Appendix I of RNTPC
Paper No. A/SK-CWBS/39A

APPLICATION FOR PERMISSION UNDER SECTION 16 OF THE TOWN PLANNING ORDINANCE (CAP.131)

CABLE ROUTE FOR PROPOSED
11kV PACKAGE SUBSTATION 'B'
AT PO TOI O

**Proposed Public Utility Installation (Package Substation and Underground Cables)
and associated Excavation of Land in “Conversation Area” Zone,
Government Land in D.D. 241, Po Toi O, Clear Water Bay**

Tree Location Plan

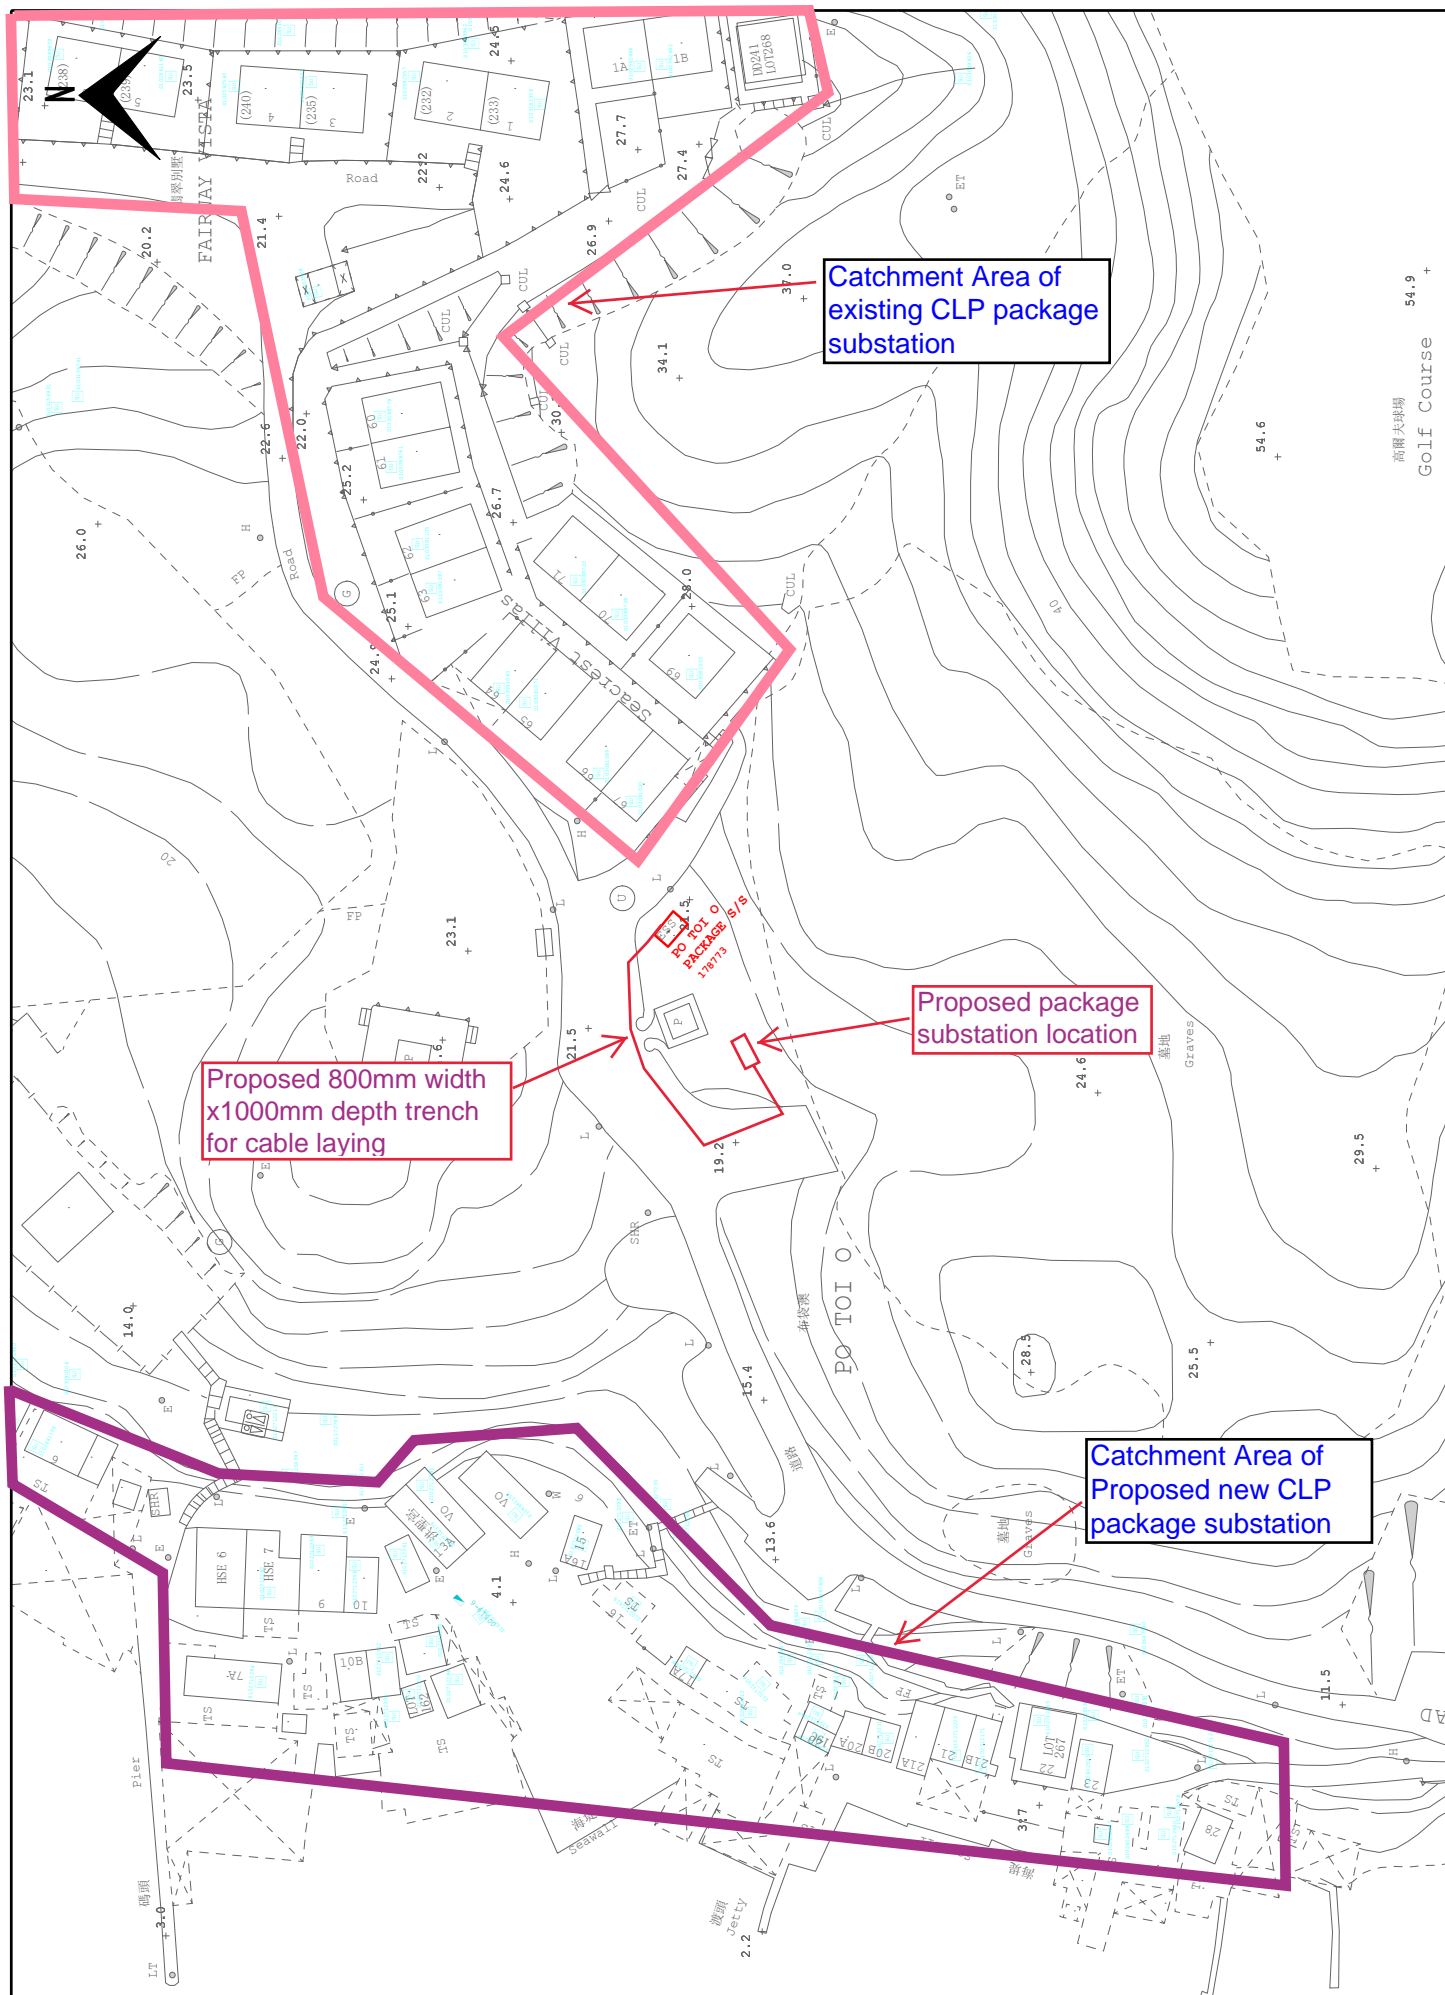
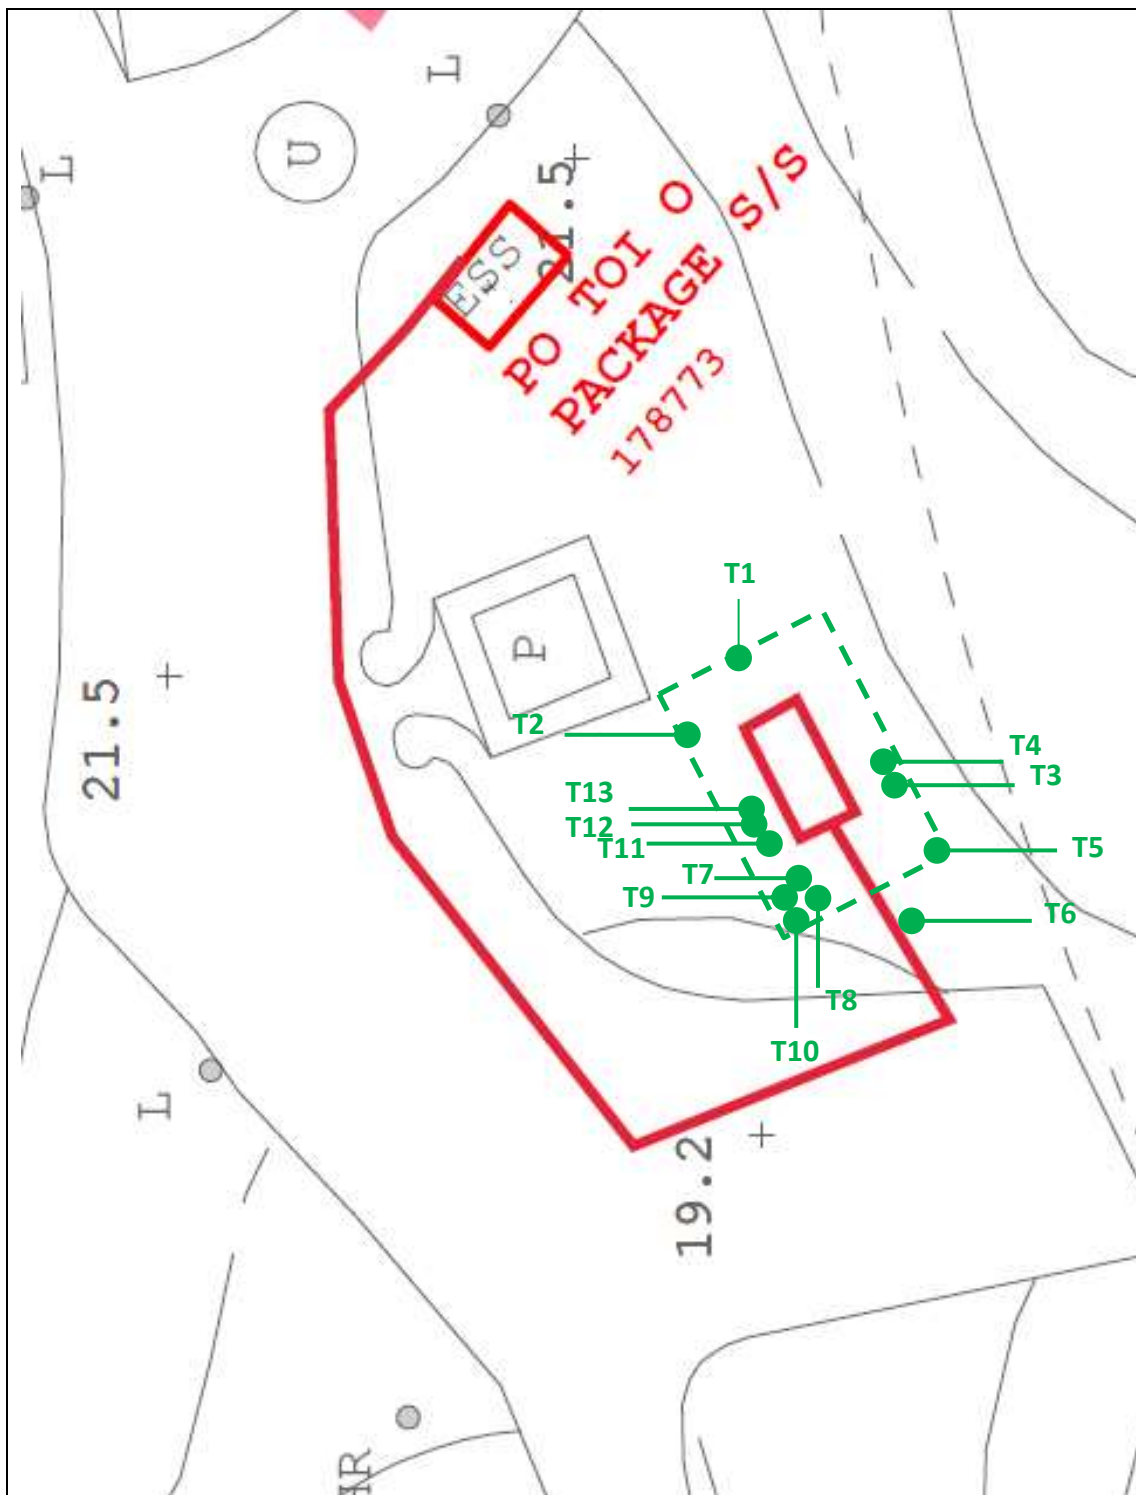
Departmental Comments	Our Responses
<p><u>Comments from UD&L</u></p> <p>"According to the site photos taken by the DPO on 23.3.2021 and our site inspection on 12.4.2021, the Site is partly on hard paved road and partly in planter. Some existing medium sized trees of common native species, including <i>Sterculia lanceolata</i> (假蘋婆), <i>Macaranga tanarius</i> (血桐), <i>Microcos nervosa</i> (破布葉), <i>Mallotus paniculatus</i> (白楸) are observed adjacent to/ adjoining the site boundary. The Site is located in an area of rural fringe landscape character predominated by woodlands and grasslands, village houses, graves and golf course to the further west. In view that the package station is a relatively small scale structure, the proposed development is considered not incompatible with the landscape character of the surrounding area."</p> <p>Although the Applicant indicates in the planning application form that no tree felling would be involved in the proposed development, according to the site inspection on 12.4.2021, the proposed location of package substation and part of the</p>	<p>Tree Survey had been conducted on 2 July 2021 to identify the tree within 2 metres from the proposed area of package substation (please see Appendix I).</p> <p>According to the recommendation in the tree survey report, no tree felling was proposed except the trees in poor conditions or found dead (Please refer to the Tree Nos. T8 – T12 of Appendix I).</p> <p>Based on the findings from the tree survey report, we re-align part of the proposed cable trench to minimize potential impact to the surrounding tree root and allow sufficient space for the tree root systems nearby (please refer to Appendix II).</p> <p>Most of the cable trench is laid under the paving area and it is considered that the potential impact to the affected landscape area is minimal.</p>

<p>cable trench appears in conflict with some of the existing trees. Since no information on existing trees and their proposed treatments is provided in the application, the potential landscape impact on the existing landscape resources could not be reasonably ascertained. The Applicant should provide additional information and clarifications on the above to facilitate our consideration of the application."</p>	
<p><u>Comments From AFCD</u></p> <p>Part 9 of the application form states that the proposed development would not cause adverse impact to the environment and no tree felling would be required. However, according to our site inspection, the application site appears to be vegetated with semi-mature trees of common species, some of which are expected to be in direct conflict with the proposed package substation and excavation</p>	<p>Tree Survey had been conducted on 2 July 2021 to identify the tree within 2 metres from the proposed area of package substation (please see Appendix I).</p> <p>According to the recommendation in the tree survey report, no tree felling was proposed except the trees in poor conditions or found dead (Please refer to the Tree Nos. T8 – T12 of Appendix I).</p> <p>Based on the findings from the tree survey report, we re-align part of the proposed cable trench to minimize potential impact to the surrounding tree root and allow sufficient space for the tree root systems nearby (please refer to Appendix II). In addition, air spray (“壓縮氣槍”) method can be applied for trench opening to further minimize the potential impact on the concerned tree roots system. Construction Safety Procedures for the Use of Air Spray (“壓縮氣槍使用安全施工程”) is attached in Appendix III.</p> <p>Furthermore, prior to our excavation works to be carried out for the subject installation, we will first inspect and identify the affected trees surrounding our works areas of its health condition and risk assessment to ensure proper measurement and actions have been implemented to minimize the impact to the trees under supervision of project manager, certified arborist and approved competent persons for locating underground electricity cables.</p>

1. The site location refers to Drawing map no. 12SW13A.
2. All the trees near of the proposed area of package substation area and cable laying are recorded in this survey report.

3. The scope of the tree survey boundary is within 2 meters from the proposed area of package substation.
4. All the surveyed trees are common species.
5. There is no tree with cultural, historic or conservation value on the site.

6. No Old and Valuable Trees (OVT), rare species (as defined by AFCD's Rare and Precious Plants in Hong Kong) is found on the survey area.
7. No Champion Trees is found on the survey area.

8. No tree was found within the proposed area of package substation.
9. A total of 13 existing trees are surveyed near the new proposed package substation area.

10. Three dead trees (T8, T11 & T12) and two irrecoverable detected trees (T9 & T10) were found near the new proposed package substation area and parking area which trees removal was recommended as soon as possible due to the public safety.

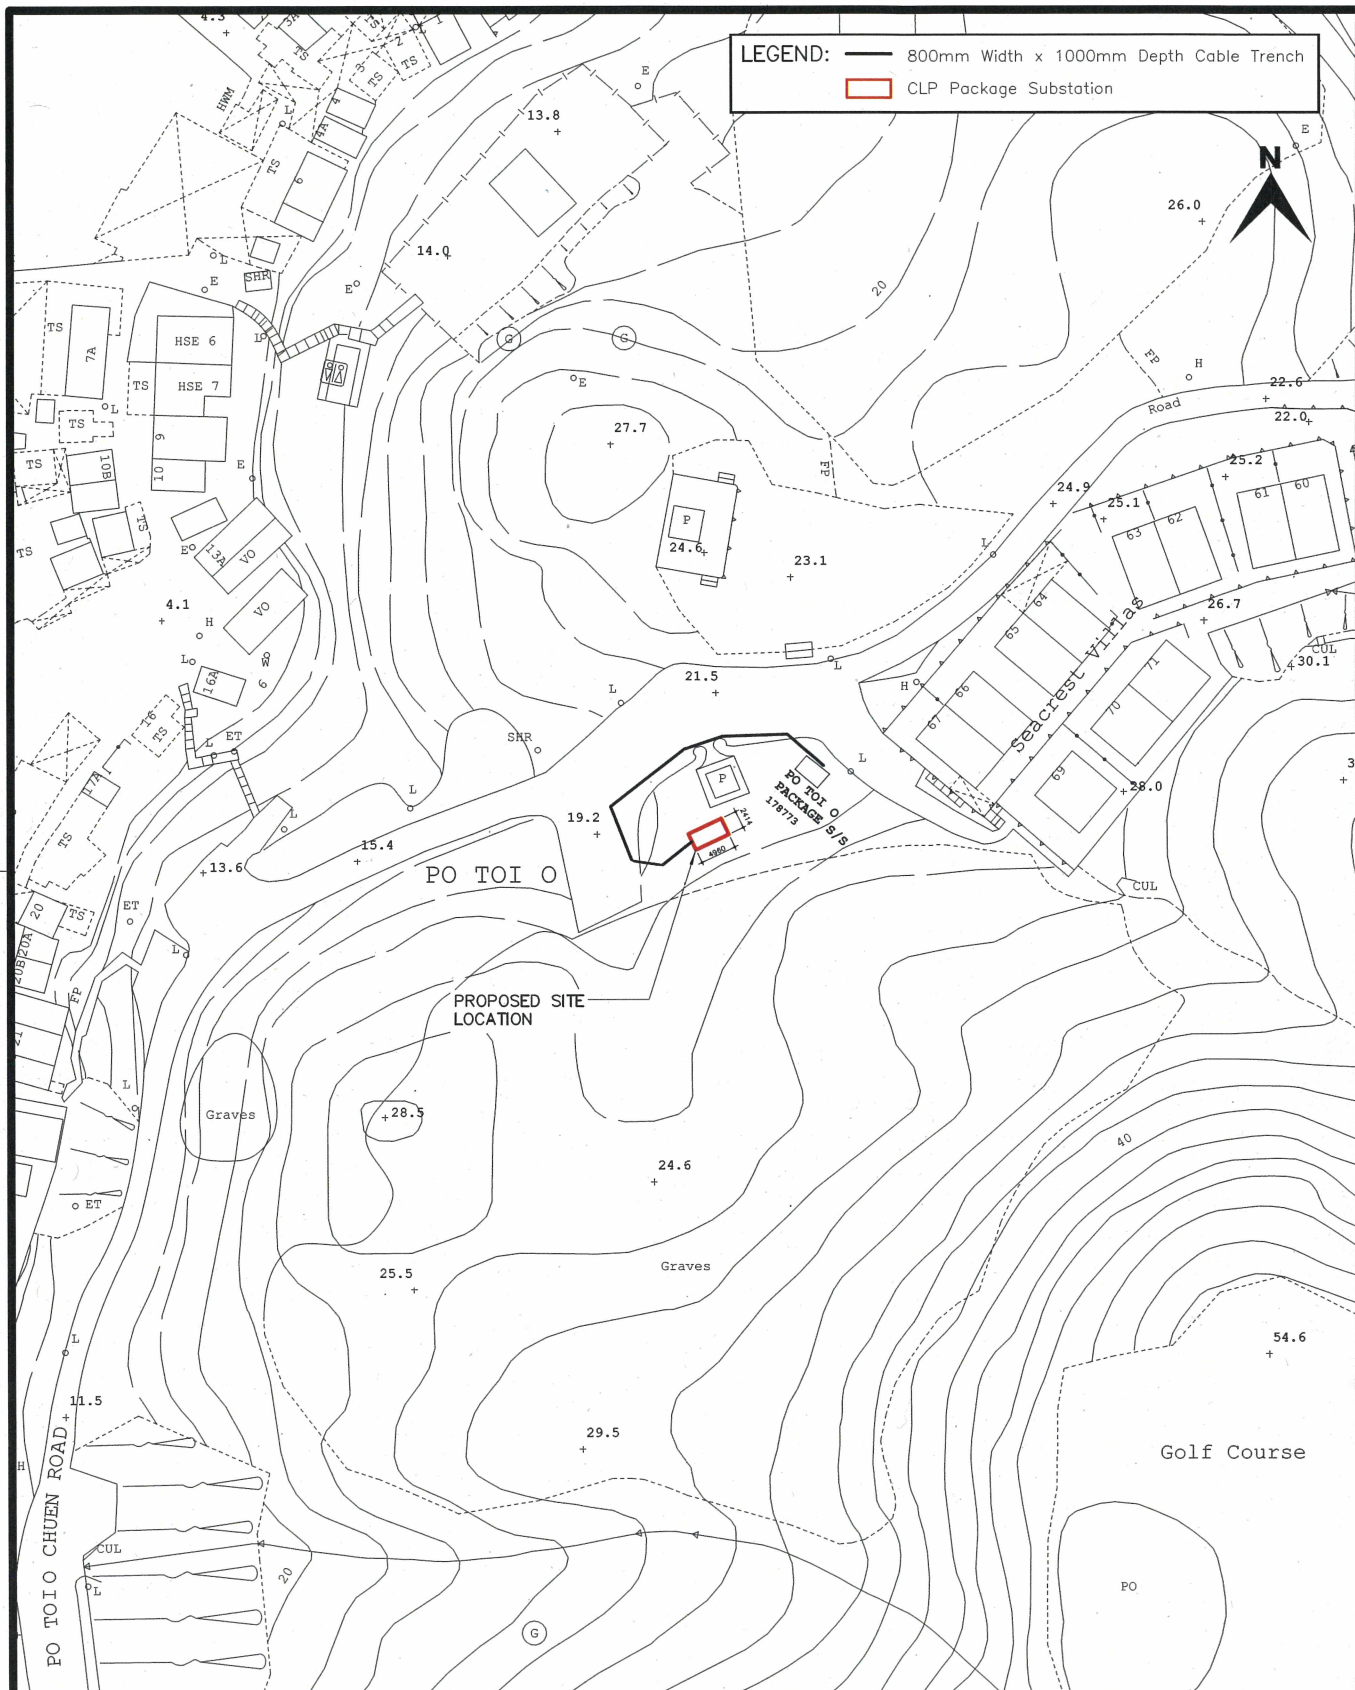
Area in Village Type Development Zone is not considered. Portion of area is located close to coastal area which is technically infeasible. Secondly, there is shortage of land supply in Village Type Development Zone which leading to physically infeasible. Besides, for area located near to the village access road is also not considered since it would affect the maneuvering of local vehicles and also response to village representative's concern on safety issues for pedestrian and vehicle driver.

It is noted that there is graveyards mostly located in the southern area of proposed package substation. The proposed location is distant and it is surrounded with trees which could minimise visual impact and response to the villager on Feng Shui concern.

After considering the above, we hereby submit further information with revised plan to justify for the planning approval. Should you have any queries, please contact the undersigned at 2678 6330.
